Product Change Notification / KSRA-06MRSR308

CCB 4610 Initial Notice: Qualification of a new lead frame with Full PPF die attach paddle (DAP) surface prep material for DSC11xx, DSC12xx and DSC81xx device families available in 6L VDFN (7x5x0.9mm) package at NSEB assembly site.

CCB 4610
Pre and Post Change Summary
PCN#:KSRA-06MRSR308

Lead frame comparison

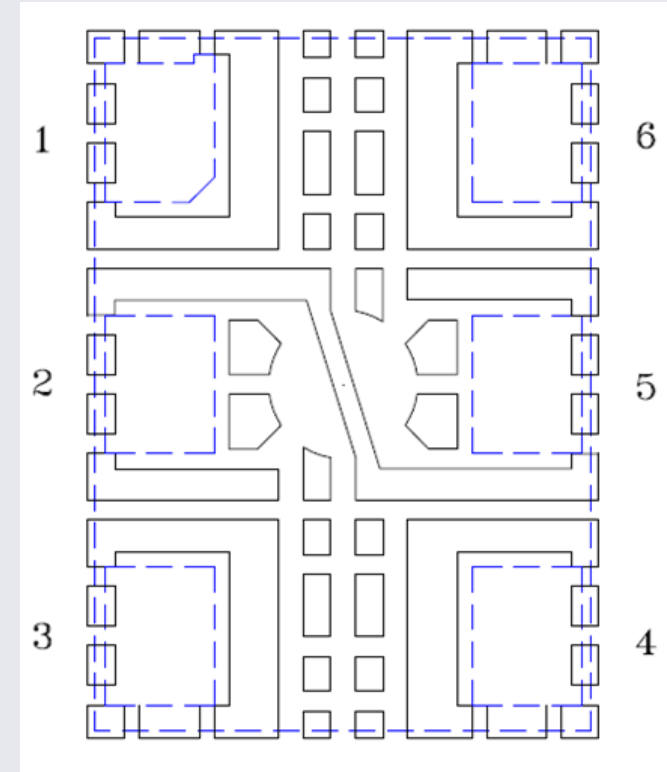
Lead frame DAP surface Prep

Selective PPF

Lead frame DAP surface Prep

Full PPF
